STAFF REPORT: JUNE 12, 2024, REGULAR MEETING **PREPARED BY:** T. BOSCARINO
APPLICATION NUMBER: HDC2024-00149
ADDRESS: 570 LODGE
HISTORIC DISTRICT: BERRY SUBDIVISION
APPLICANT: JOHNATHON FISHER
OWNER: JOHNATHON FISHER
DATE OF PROVISIONALLY COMPLETE APPLICATION: APRIL 30, 2024
DATE OF STAFF SITE VISIT: MAY 23, 2024; JUNE 5, 2024

SCOPE: DEMOLISH GARAGE, ERECT GARAGE, ERECT REAR PORCH, PAINT DWELLING (WORK STARTED WITHOUT APPROVAL)

The front (west) elevation of the proposed garage. Image from application documents.

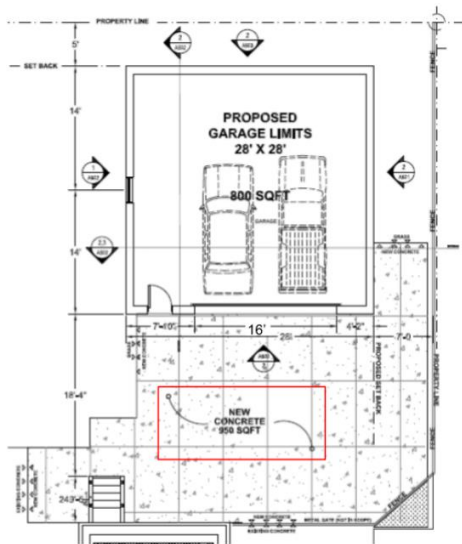
The proposed work would replace the existing garage with a new garage. The new garage would be clad in brick veneer matching the color and texture of the house and have a grey asphalt shingle roof. Specifications for other materials, such as doors, soffits, and fascia, are not provided. Also note that two alternate roof pitches are proposed.

- The massing and materials of the proposed garage are compatible with property and the district. (The application materials propose two alternate gable configurations; both are acceptable.)

- The front-facing gable end of the proposed garage creates a relatively large, blank expanse of brick that is out of character for the district. The attic story of a masonry or brick veneer garage would traditionally use a contrasting, and lighter, material, usually wood siding. The proposed design, therefore, is contrary to Standard #9 (quoted above).
- Specifications for garage materials are not provided.

- *The front-facing, gable end, attic story of the garage shall employ a contrasting material, such as wood or a synthetic substitute.*
- *Garage materials and revised design shall be subject to review by staff.*

Proposed porch. Elevations from application documents.

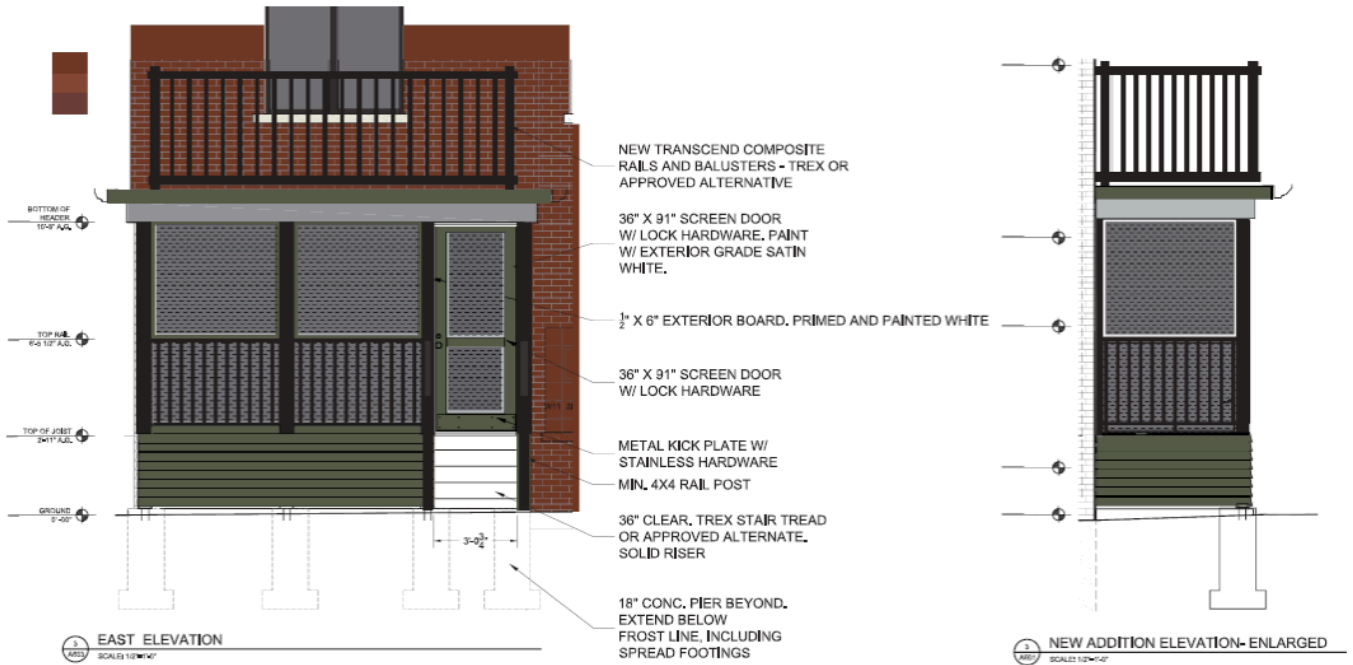
The application proposes to remove the rear addition (already removed without approval) and erect a porch. Proposed is a screened porch, mostly of wood, though a balustrade and stair treads would be of composite material.

- The proposed porch is compatible in materials and massing, and yet its design differentiates it from the historic rear porch. This satisfies Standard #9: “New additions, exterior alterations, or related new construction shall not destroy historic materials that characterize the property. The new work shall be differentiated from the old and shall be compatible with the massing, size, scale, and architectural features to protect the historic integrity of the property and its environment.”

Existing colors (left) and rendering of proposed colors (right). Images from application materials.

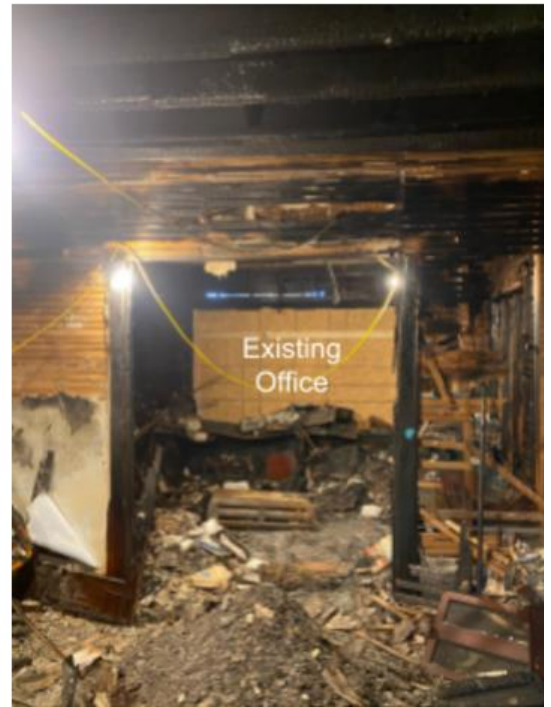
The house and proposed garage are proposed to be painted in C1: Light Bluish Grey, B19: Black, and B11: Greyish Olive Green.

- The proposed color scheme is creative and atypical, though perhaps not to the extent that it is incompatible with the building or the district. Lighter trim colors are more appropriate for Colonial Revival architecture, as described in the Berry Subdivision Elements of Design and in Color System C, with black or dark green reserved for window sashes and shutters. The use of contrasting white and dark accents on the same architectural feature would also be unusual.
